Reference: Banner University Medical Center Planned Area Development
GLHN #1520.00

Subject: Minor Change for Parking and Parking Area Access Lanes

SUBJECT: Banner University Medical Center Planned Area Development (PAD), Minor Amendment – Compact Parking Spaces and Parking Area Access Lanes

Exhibit 1: Compact Parking Stall

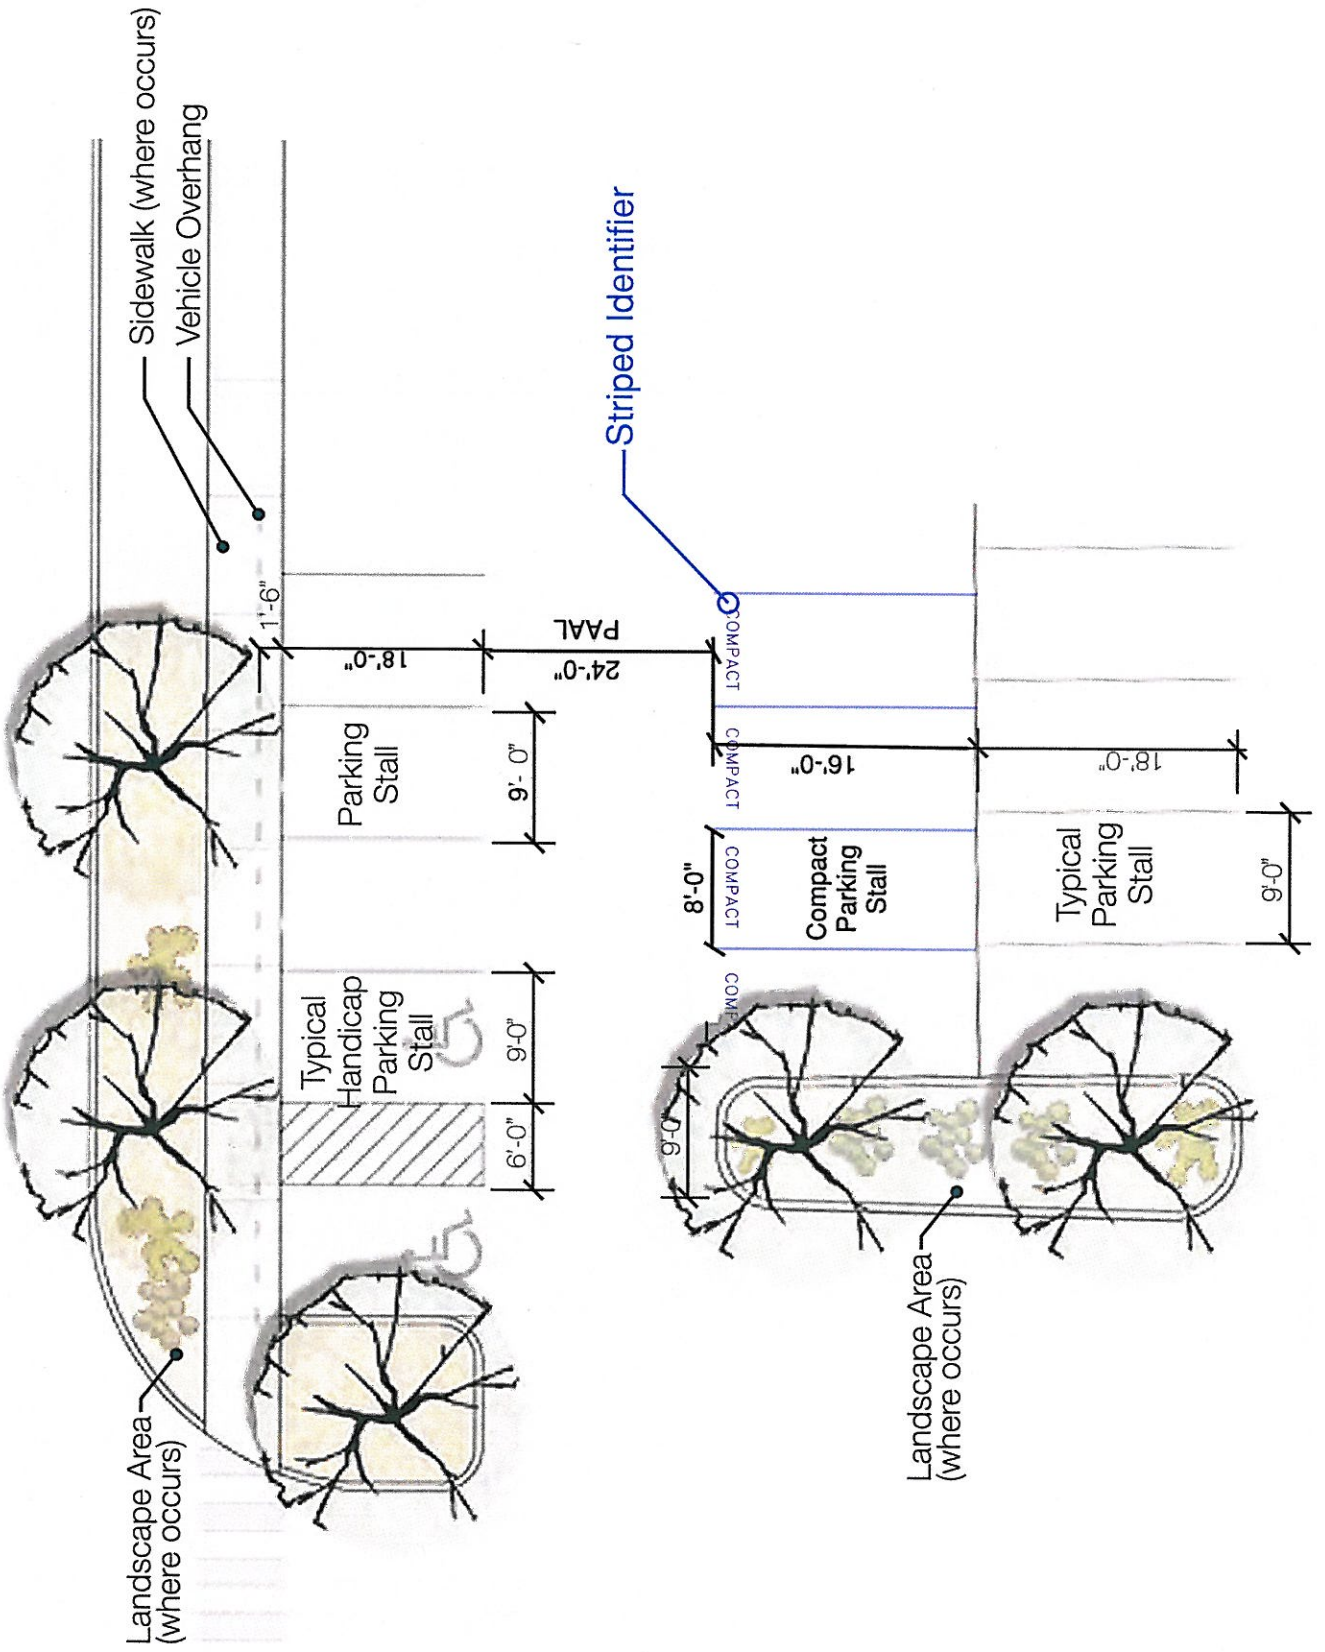
Due to site constraints in the south surface parking lot, the available north-south dimension of the lot does not allow for the layout of 18-foot deep standard parking spaces with an adjacent 24-foot PAAL. With the goal of maximizing the on-site parking and not reducing the landscape areas, several alternatives were reviewed including angled parking, varying PAAL widths, and compact parking spaces. The results of this evaluation indicated that to maintain the desired 310 spaces requires the use of two rows of compact parking at 8 ft. x 16 ft., or utilizing one 20-foot, one-way parking area access lane adjacent to 90 degree parking spaces.

- 1) Permit the use of compact car parking spaces (8 ft. x 16 ft.), up to a maximum of 15% of the total required standard parking spaces. All compact parking spaces will be clearly marked, and standard size spaces will be available in close proximity to the compact spaces.
- 2) Allow 20-foot wide, one-way parking area access lanes adjacent to 90-degree parking spaces. Proposed one-way parking area access lanes will be controlled with pavement marking and signage.

Therefore, it is determined that the request for compact parking spaces and parking area access lanes as presented in attached Exhibit 1: Compact Parking Stall and Exhibit 2: 20-foot One-Way PAAL.

1. Parking design flexibility will not negatively impact safety of the hospital facility.
2. Will allow the hospital expansion to provide a high ratio of accessible parking spaces within close proximity to the new entrances.
